2023 Iso-Settlement Survey

Operable Unit 2 Landfills

Former Fort Ord, California

Report Version: **Draft Final**

Sheet reference number:
C-11

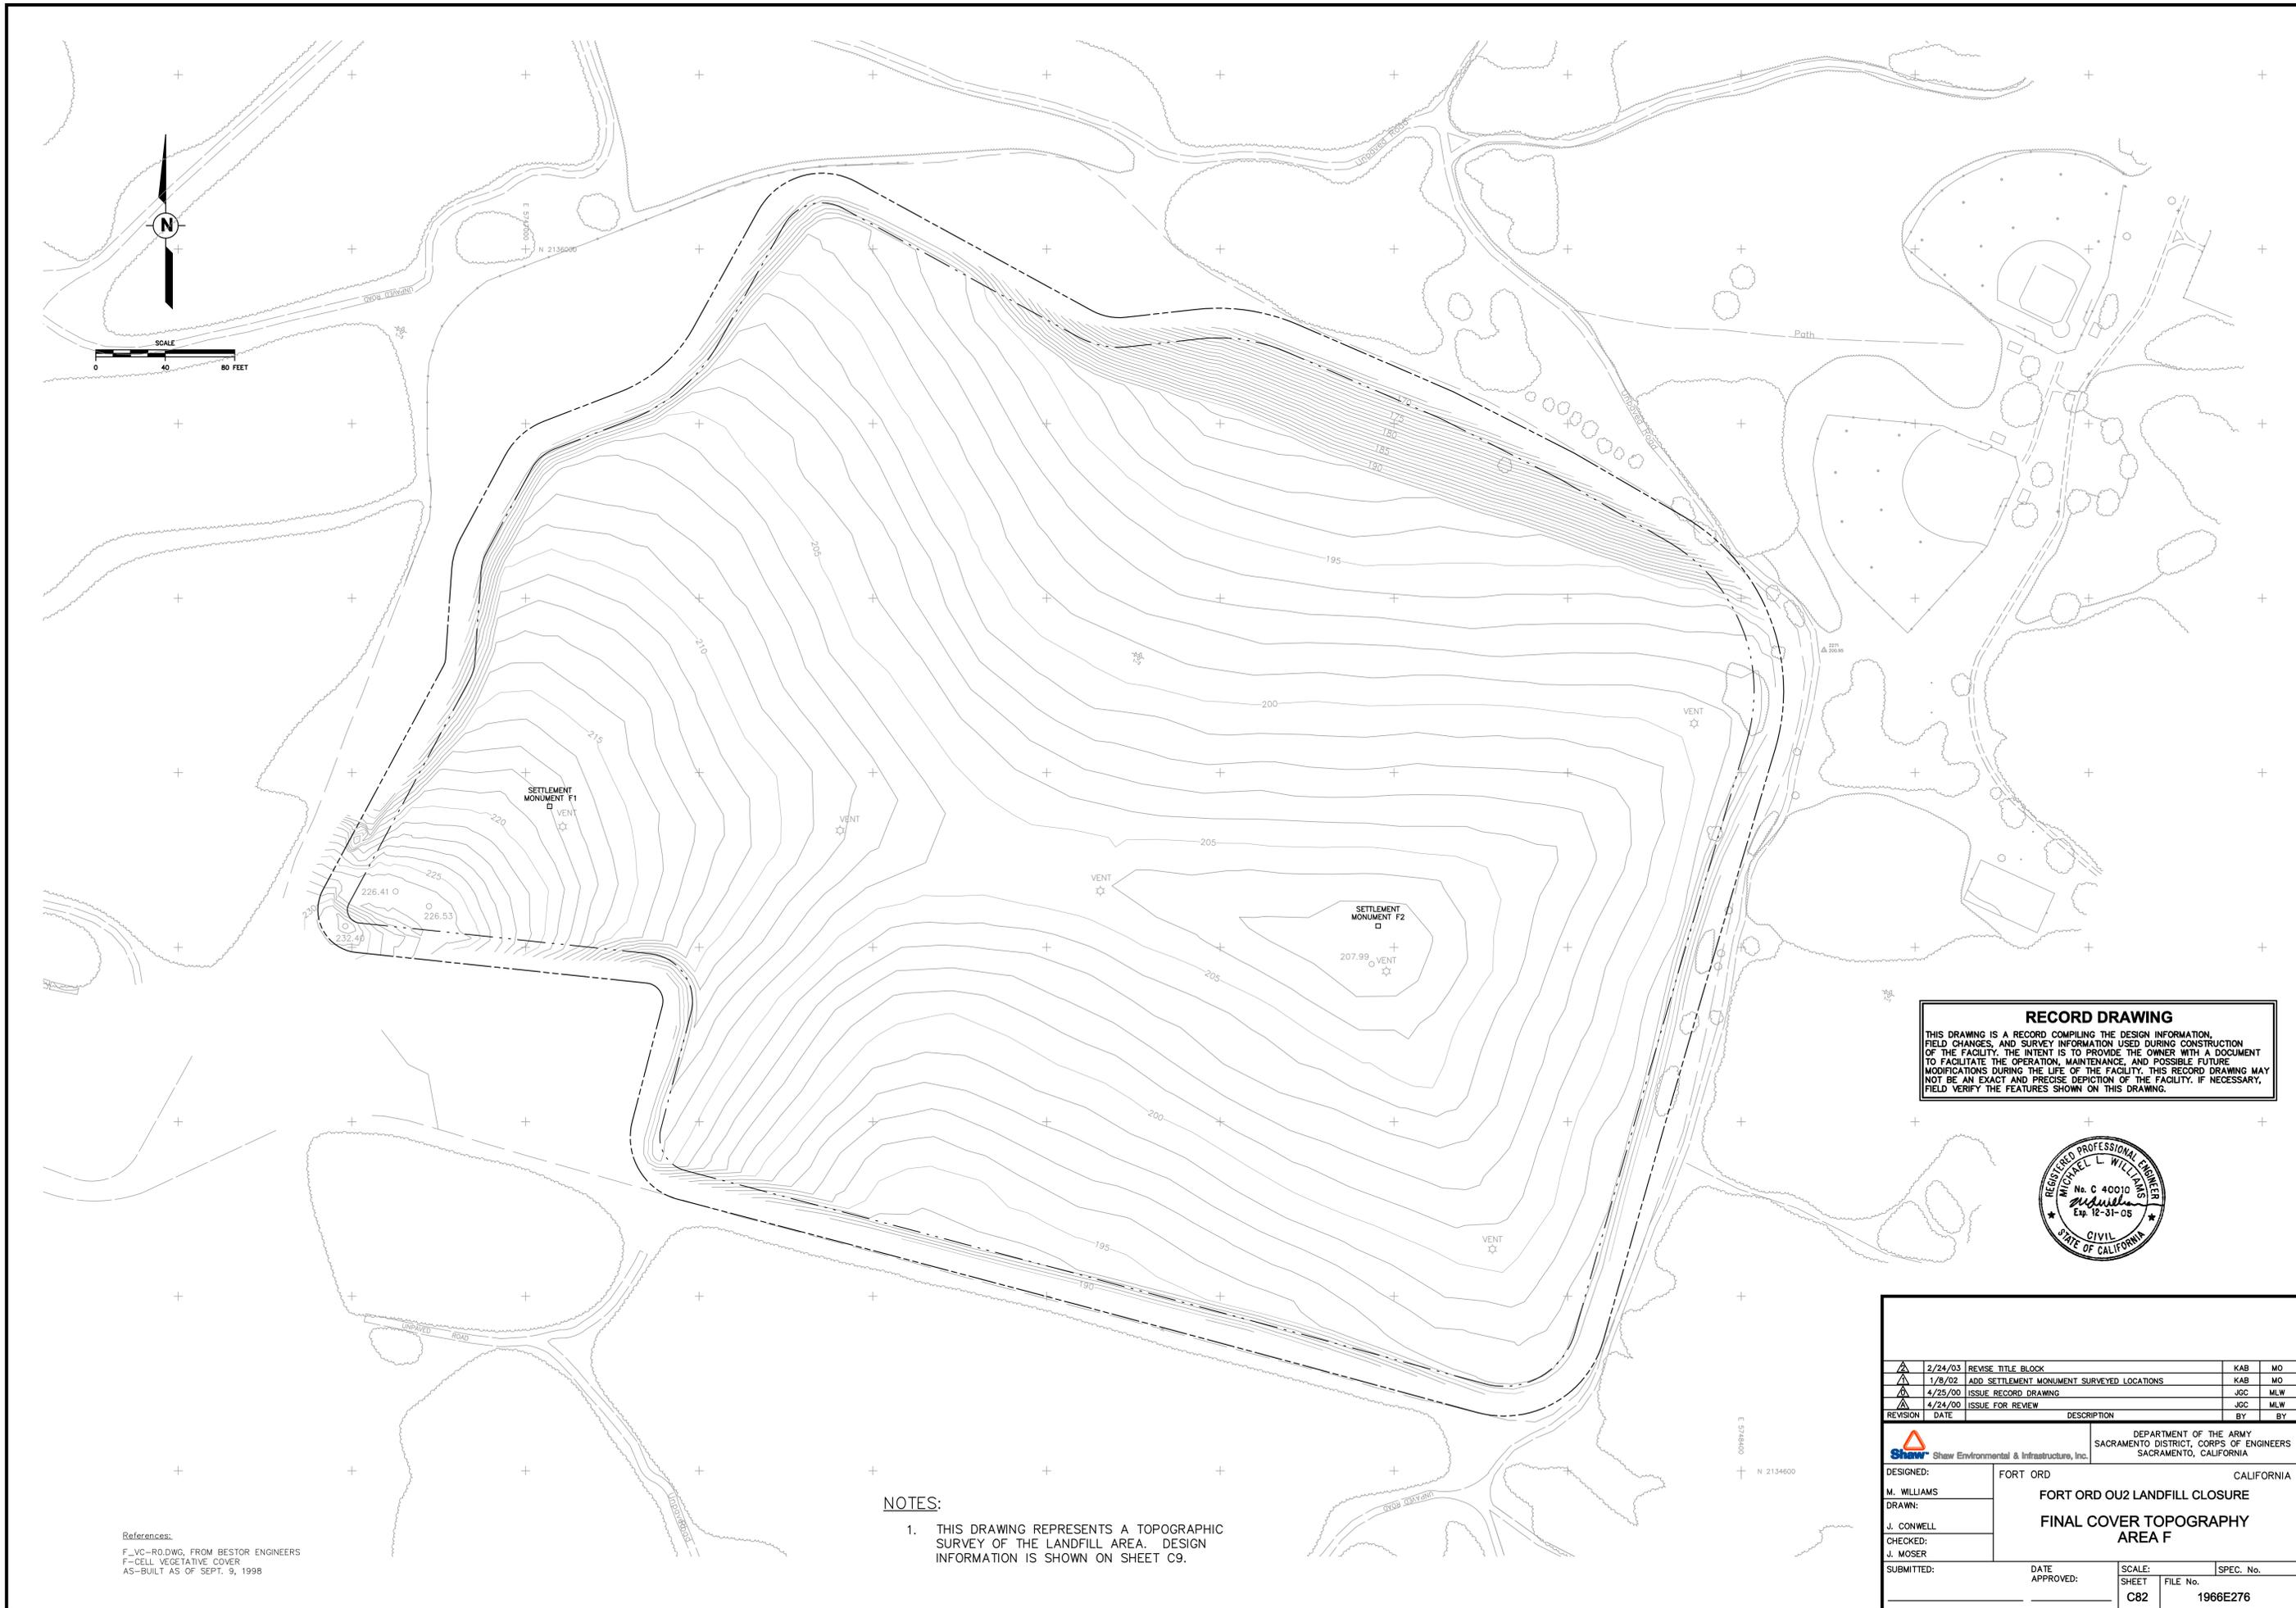
ESPO COMMENT 4: ESPO notes that Sheet C-11 in Attachment C (Page 43) is referred to on Page 8 as being part of Area E. However, this reviewer’s comparison of Sheet C-11, which has no Area designation, with the drawing on the prior Page 42, which is designated as related to Area E, shows no resemblance. This casts doubt as to the particular Area that is intended to be shown on Sheet C-11.

ESPO recommends that Sheet C-11 of the Iso-Settlement Survey be revised to clarify what is being shown.

RESPONSE TO ESPO COMMENT 4: *The title block on Sheet C-11 states that it depicts a portion of Area E, specifically the Phase 1 cover topography. Additionally, certain features on Sheet C-11, such as settlement monuments, landfill gas vents and bollards, and gravel roads, can be correlated with the same features shown on Sheet C81, which shows all of Area E. Further, Sheet C-11 is a signed and approved record drawing. Sheet C-11 was not revised per the comment.*
